**SERVICE BULLETIN**  
**NO:06011-R3**

MODELS : TX-SR674 / TX-SR804 / DTR7.7

SUBJECT : Picture Interruption in output of 1080P signal via HDMI on Playstation 3

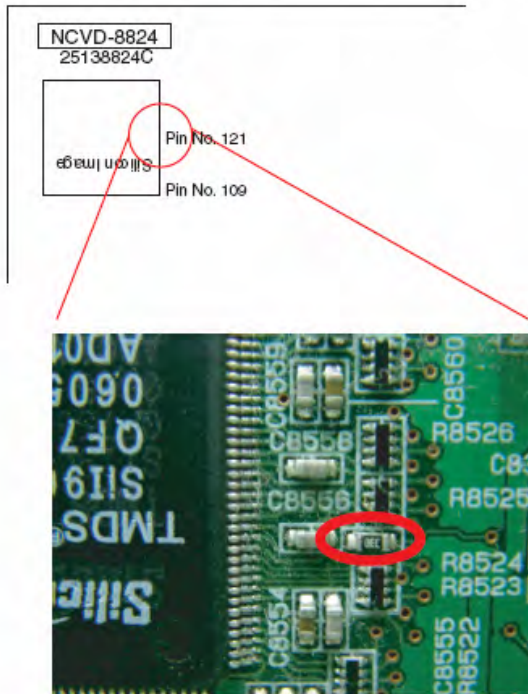
- 1) Remove Capacitor C8428 on HDMI Board NAVD-8824.
- 2) Change Resistor at R8524 from 33 ohm to 0ohm on HDMI Board NAVD-8824.

C8428 Remove this capacitor.

R8524 Change Resistance Value from 33ohm to 10ohm.

The resistance value of R8524 was changed to 22ohm first and then to 10ohm again. and finally to 0ohm . 0ohm is the best and 10ohm is better, but 10ohm and 22ohm are also effective. Therefore, when 22 or 10 ohm Resistor is mounted at R8524, it is not necessary to replace it by 0ohm Resistor as long as the unit has no problem.
